**Meeting Agenda
Plat Committee**

Monday, September 12, 2022

1. [KPB-4574](#) Hamm Subdivision; KPB File 2022-120
Attachments: [E1. Hamm Subdivision Packet](#)
2. [KPB-4575](#) Kasilof Alaska Subdivision 2022 Replat; KPB File 2022-119
Attachments: [E2. Kasilof AK Sub 2022 Replat Packet](#)
3. [KPB-4576](#) Levan-Sterling Subdivision; KPB File 2022-125
Attachments: [E3. Levan-Sterling Sub Packet](#)
4. [KPB-4577](#) O'Rourke Subdivision Matranga Addition; KPB File 2022-124
Attachments: [E4. O'Rourke Sub Matranga Addn. Packet](#)
5. [KPB-4578](#) The Lady L Ranch; KPB File 2022-123
Attachments: [E5. The Lady L Ranch Packet](#)

KPB 2022-120

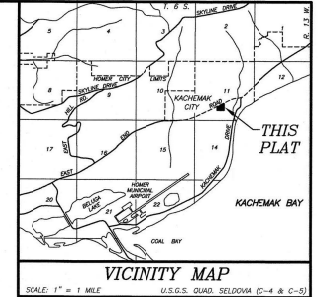
A dedication for the western half of Collie Street is being proposed to bring the width into compliance. An exception to KPB Code 20.30.100, Cul-de-sacs, is being requested. A structure is located at the end of the proposed dedication. This structure limits the ability to receive a dedication to complete the cul-de-sac. Collie Street is maintained by the City of Homer. Per the City of Homer staff report, the public works did note that the design did not meet their design criteria as the cul-de-sac was not complete. Due to the structures, the planning department recommended to not require any additional dedication other than what was proposed on the preliminary design. The Planning and Zoning Commission agreed. The staff report did state there was no comment from their Fire Department. ***Staff recommends the surveyor/owners work with the City of Homer to verify that the proposed design will meet their needs for a proper turnaround area and if needed dedicate additional right-of-way north of the structure to provide a modified t-type or hammerhead turnaround.***

*On the graphic scale, the last number 480 is incorrect.
Check distances along east line for totals accumulated.
If the plat committee concurs that no exception is required, remove plat note 10.*

Staff recommendation: *In the legal description, check the reference plats and filings, there appears to be combinations of two different plats names and filing pages as well as some information missing. Refer to the Certificate to Plat for correct legal.
Add KPB number 2022-120.*
- C. The location, width, and name of existing or platted streets and public ways, railroad rights-of-way, and other important features such as section lines or political subdivisions or municipal corporation boundaries abutting the subdivision;

Staff recommendation: *The city limit boundary between Homer and Kachemak City is within the East End Road dedication. Provide a city limit boundary and label each side accordingly.*
- G. The status of adjacent lands within 100 feet of the proposed subdivision boundary or the land status across from any dedicated rights-of-way that adjoin the propose subdivision boundary, including names of subdivisions, lot lines, block numbers, lot numbers, rights-of-way; or an indication that the adjacent land is not subdivided;

C. Temporary turnarounds and self-vacating turnarounds shall not be granted or reserved on plats.
Staff recommendation: *Rather than an exception, possibly contact with emergency services to do a modified half of hammerhead on the proposed dedication to blend into the existing dedication.*

D. Intersections of access streets with arterial streets or state maintained roads must be designed to the American Association of State Highway and Transportation Officials (AASHTO) standards.
Staff recommendation: *Appears to be 65 degrees. Verify and adjust as required.*

Staff recommendation: *Add to the acceptance the drainage easement requested by the City of Homer.*

Staff recommendation: Lot 1 will need water service and Lot 2 will need sewer service. Provide an installation agreement or documentation that one is not required.

SCALE 1" = 100'
3 August, 2022

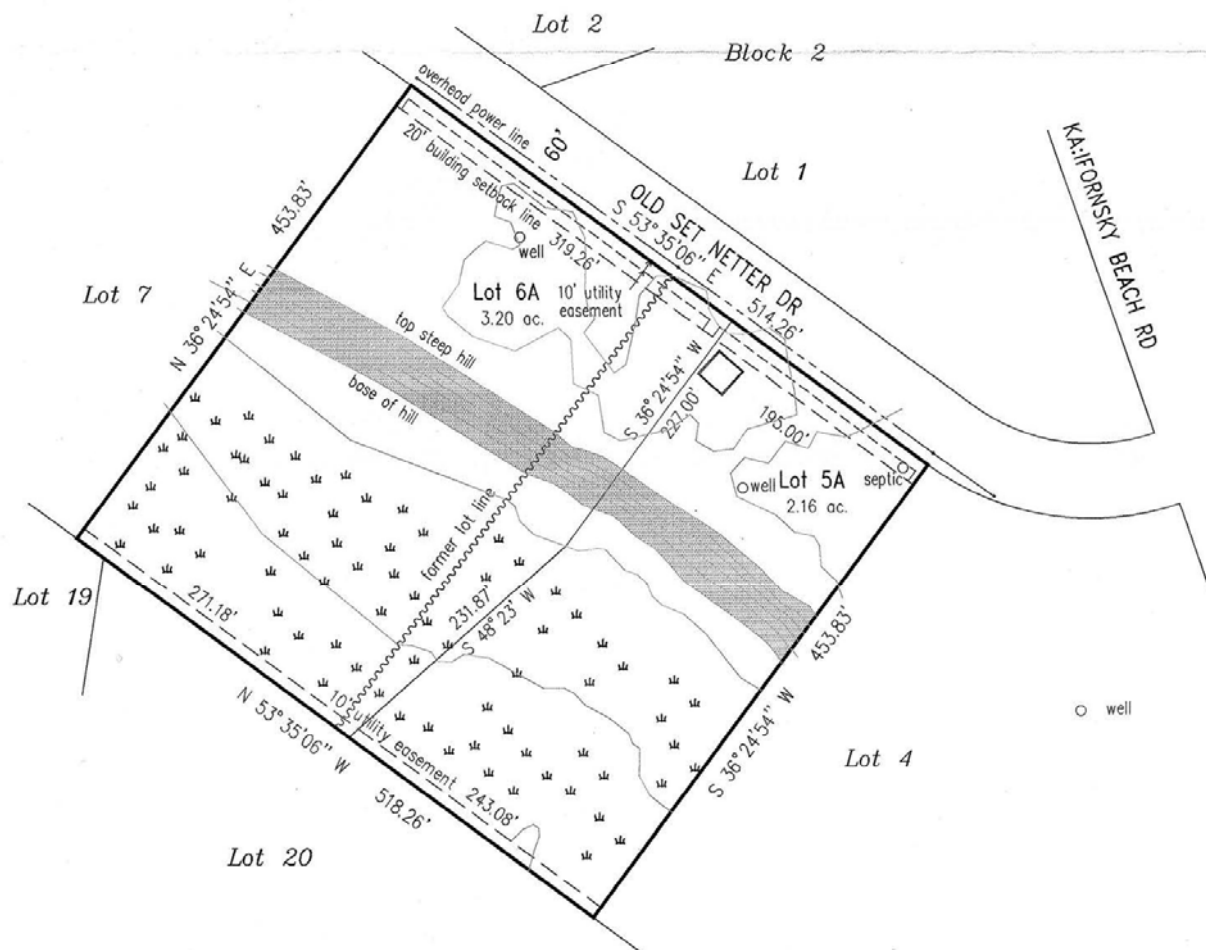
Site Investigation: The replat is flat along the road and then drops steeply in the middle of the lots to wetlands at the back of the lots. **Staff recommends the top and base of the hill remain on the final plat as well as the low wet areas and add a wetland determination plat note.**

HEA	Revise utility easement at the new lot line. Provide a 20-foot-wide electric easement centered on the existing overhead electric line for any portion of the secondary service that crosses Lot 6A and provides electricity to 5A that will not be encompassed by the easement that adjoins Old Setnetter Drive.
ENSTAR	No comment
ACS	
GCI	Approved as shown

<p>List of Correct Street Names:</p> <p>Existing Street Name Corrections Needed: OLD SET NETTER DR should be OLD SETNETTER DR KA:IFORNSKY BEACH RD should be KALIFORNSKY BEACH RD</p> <p>All New Street Names are Approved: No</p> <p>List of Approved Street Names:</p> <p>List of Street Names Denied:</p> <p>Comments: 28395 OLD SETNETTER DR will remain with 5A. 28415 OLD SETNETTER DR will remain with 6A.</p>
Code Compliance	<p>Reviewer: Ogren, Eric</p> <p>Comments: No comments</p>
Planner	<p>Reviewer: Raidmae, Ryan</p> <p>There are not any Local Option Zoning District issues with this proposed plat.</p> <p>Material Site Comments: There are not any material site issues with this proposed plat.</p>
Assessing	<p>Reviewer: Windsor, Heather</p> <p>Comments: No comment</p>

Check distances on back lot line compared to parent plat.
Show pins found or set on drawing.
Show basis of bearing on plat.
Show measured and recorded distances and bearings on drawing.
If this drawing was created from non-surveyed data, a note should have been added stating such.
Add surveyors' certificate and seal
Add legend

DRAWN BY: VLB	DATE: 08/18/2022	PROJECT: 22-576
CHECKED BY: MA	SCALE: as noted	SHEET: 1 OF 1

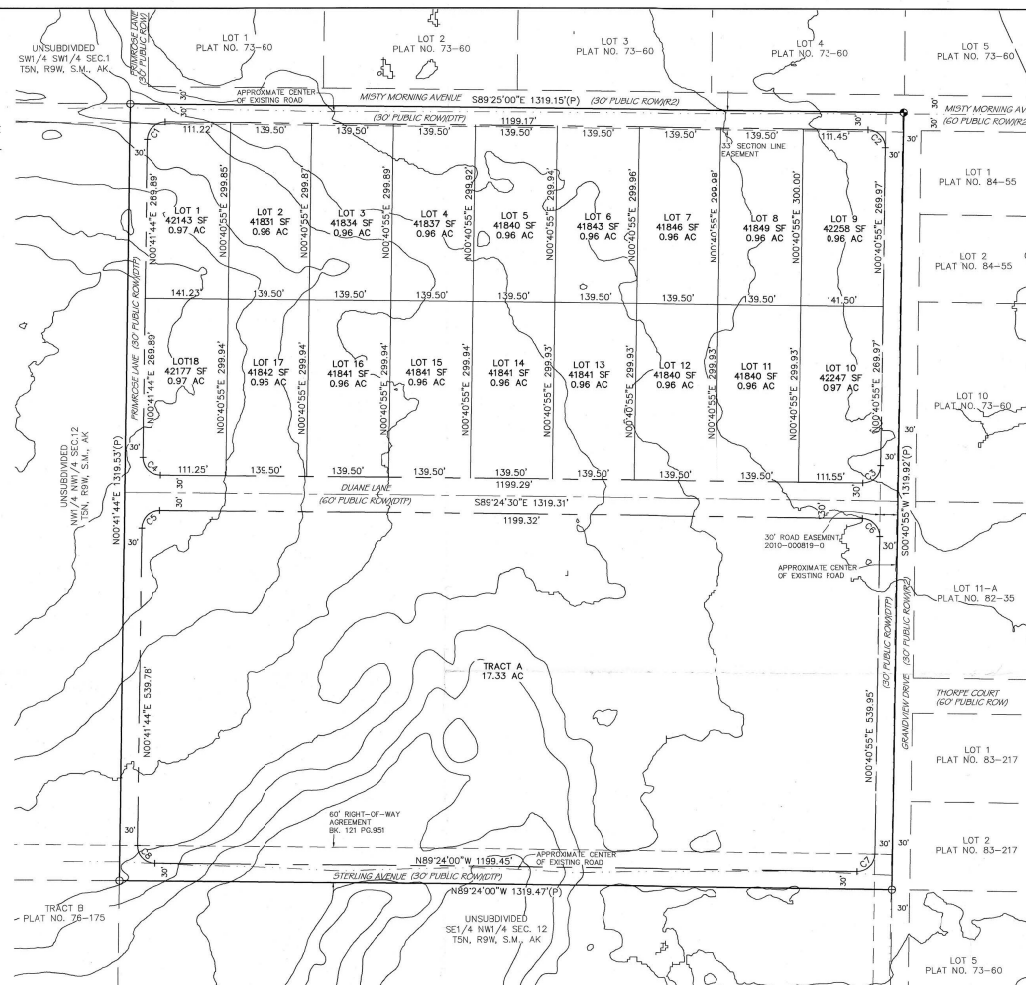
Along the eastern boundary the plat shows a 30-foot right-of-way dedication for Grandview Drive to bring the right-of-way into compliance for width. Grandview Drive is constructed and maintained by the borough. This dedication is occurring atop a public easement granted by recorded document. **Staff recommends the easement label include "public" or a plat note be added that includes the details and description of location and states it is now within the dedicated portion of Grandview Drive.**

- providing a 30 foot dedication as currently proposed and make sure the pipeline is within the edge of the right-of-way or north of the dedication, or
- provide a reduced width for the right-of-way to not have the dedication atop the pipeline, or
- provide a full 60 foot dedication that is north of the existing pipeline.

New utility easement as identified in note 2 as “the front 10’ of the 20’ Building Setback and the entire 20’ Building Setback within 5’ of side lot lines”. A typical building setback detail is provided that shows the setback and utility easements as described within the plat note. **Staff recommends the plat note include “granted by this plat”.**
